SUBJECT: PLANS AND PROPOSAL ADDENDUMS
PROJECT: STP 2023 (675)MM CONTROL: 1433-02-044
COUNTY: COMAL
LETTING: 05/04/2023
REFERENCE NO: 0419

PROPOSAL ADDENDUMS

DESCRIPTION OF ABOVE CHANGES
(INCLUDING PLANS SHEET CHANGES)

**PLAN SUBJECT TO CHANGE
AS UTILITIES ARE INSTALLED**

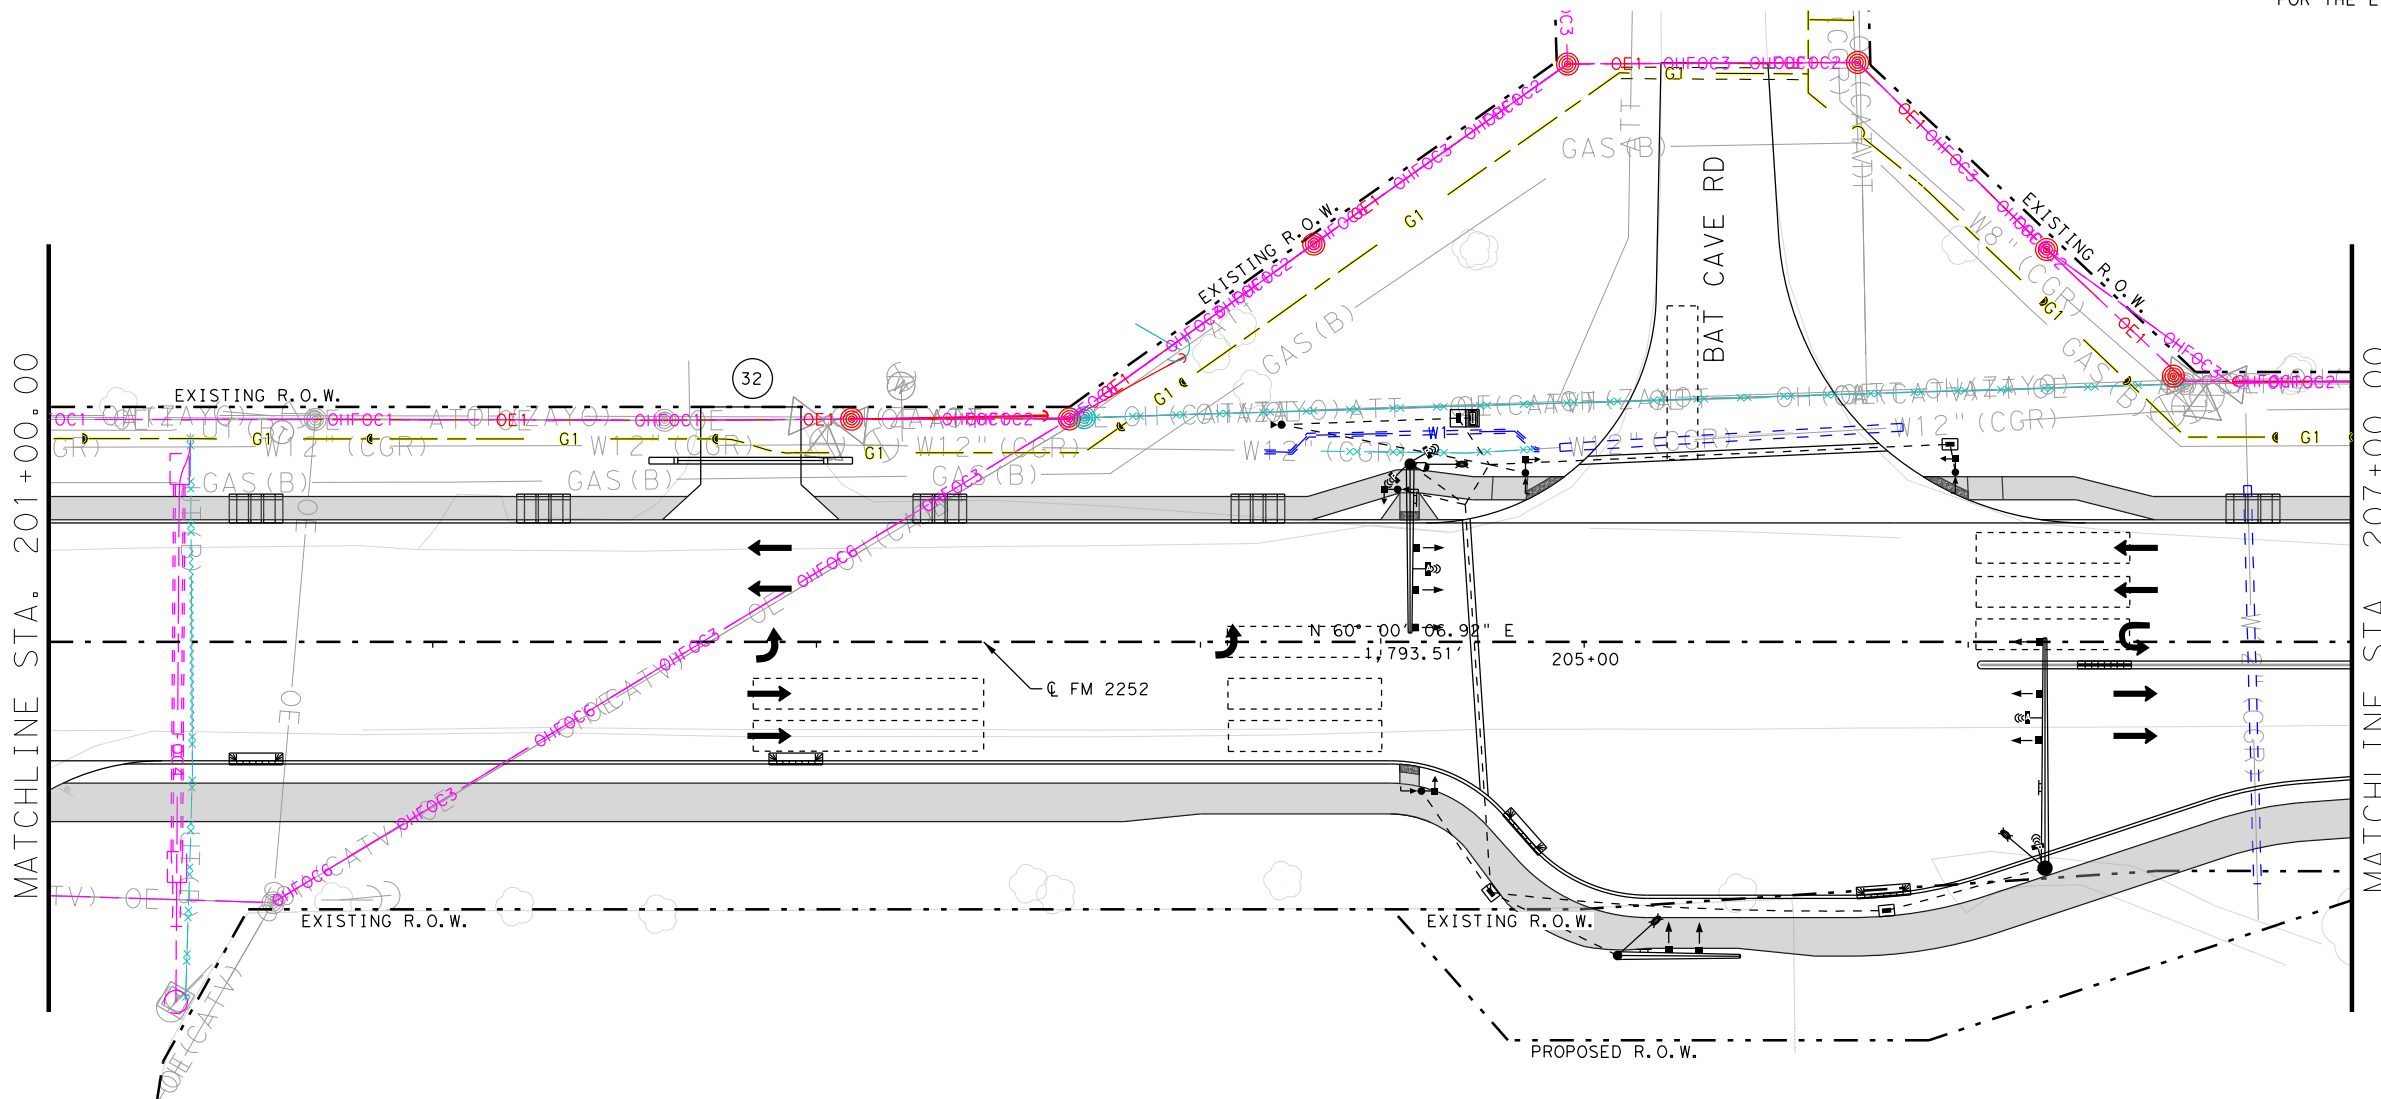
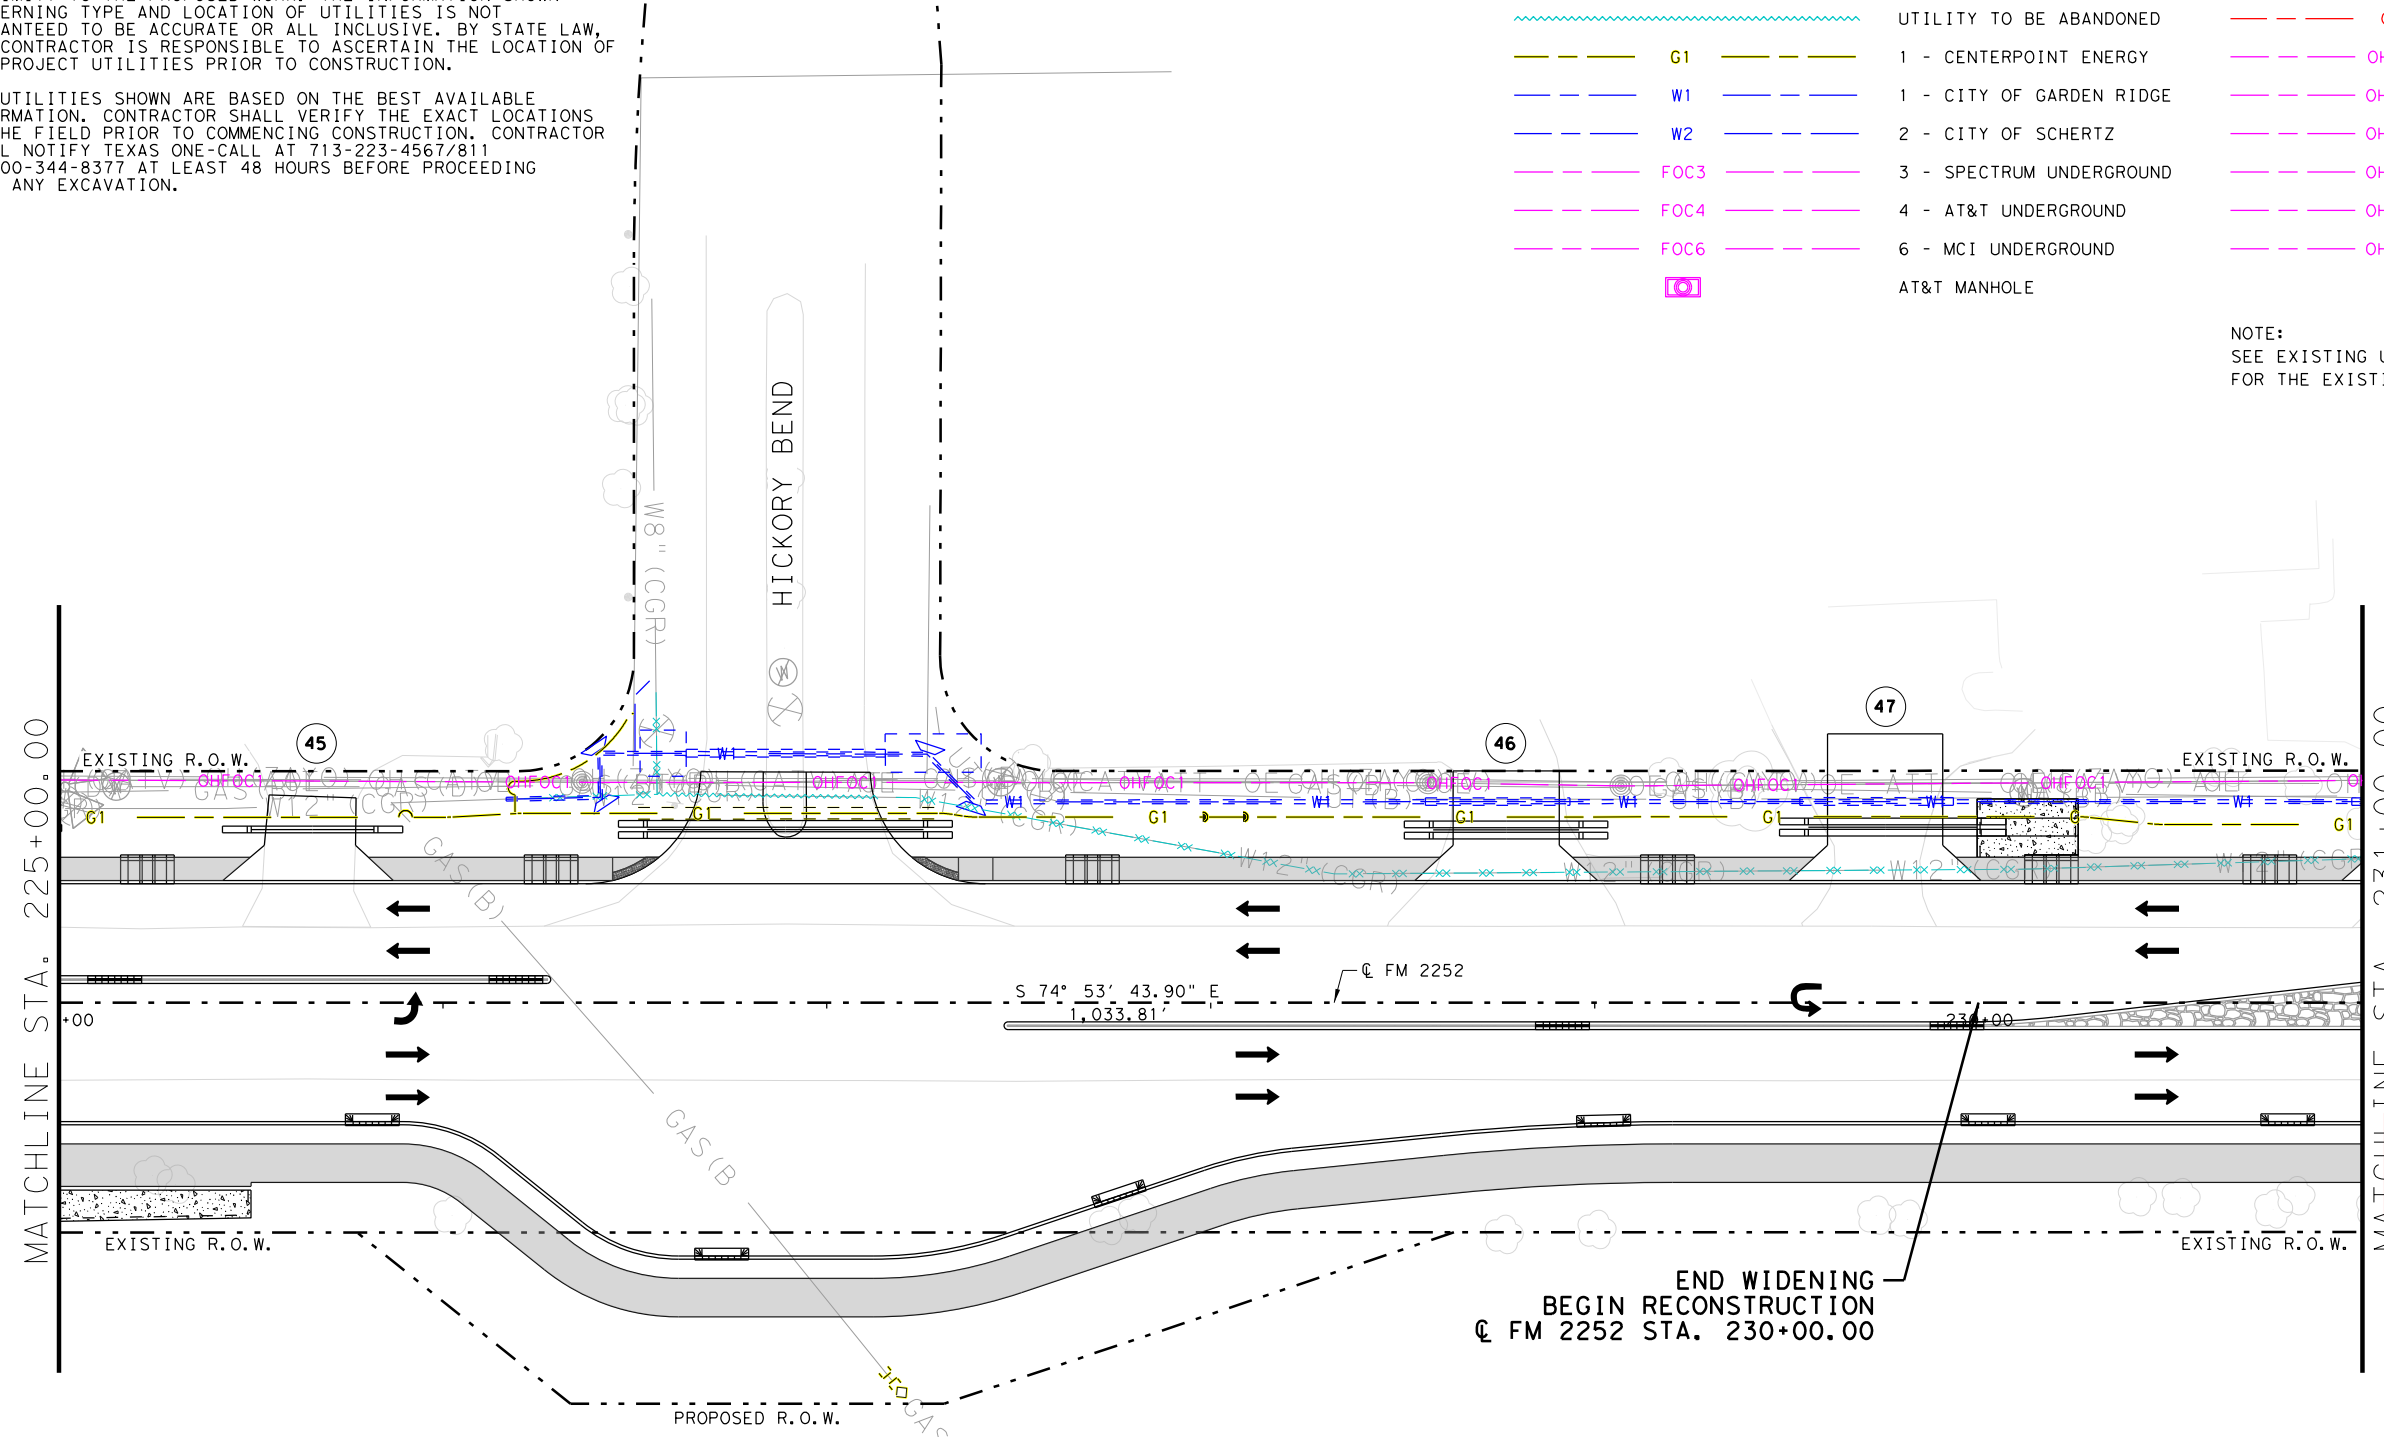
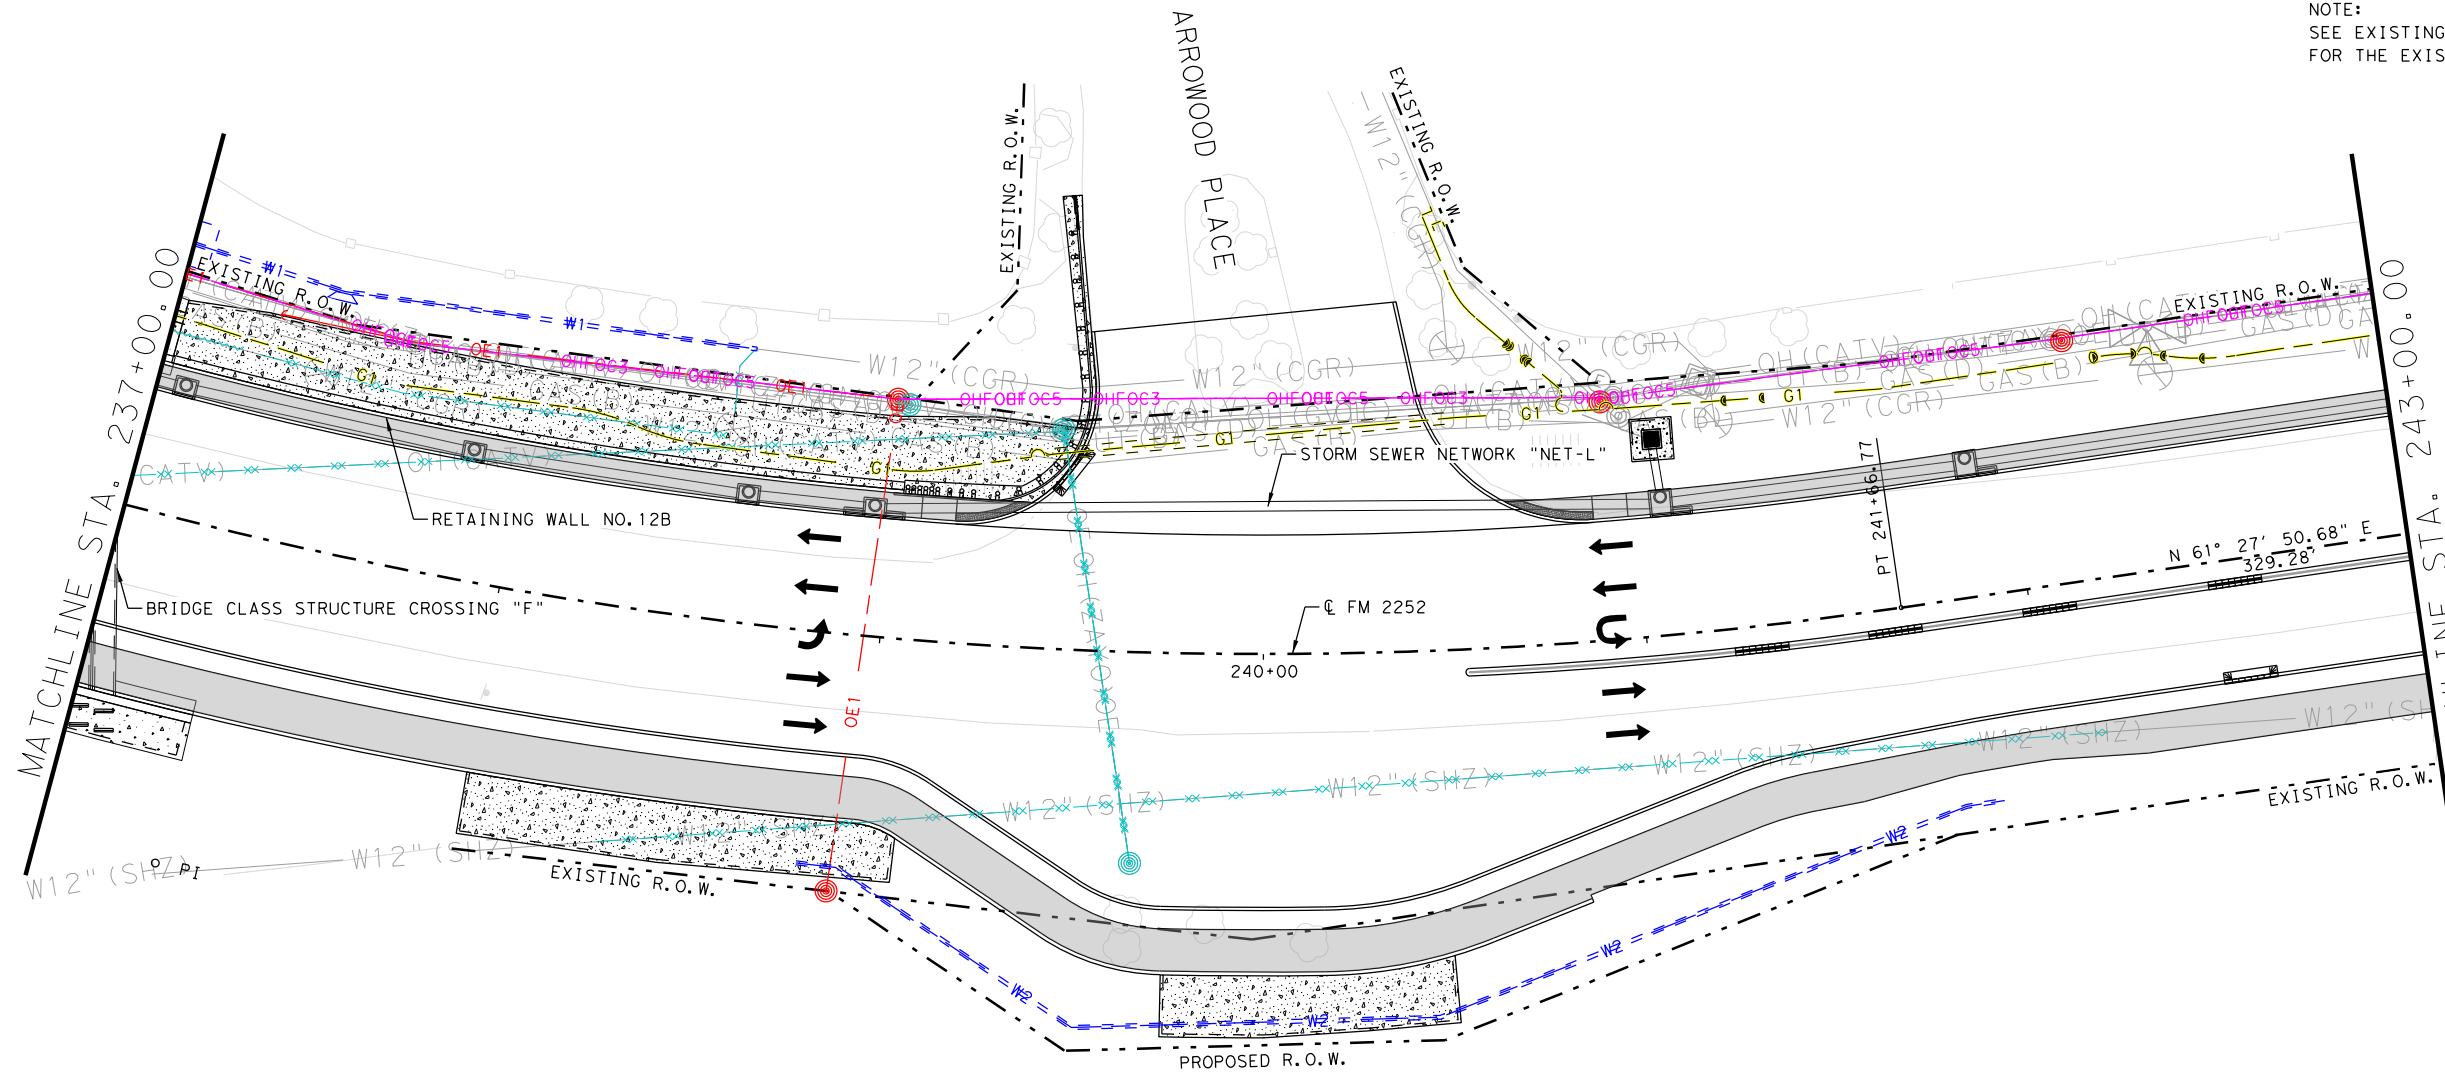
SHEETS 1330-1365: UPDATED UTILITY PLANS SHEETS LAYOUTS WITH CURRENT GAS
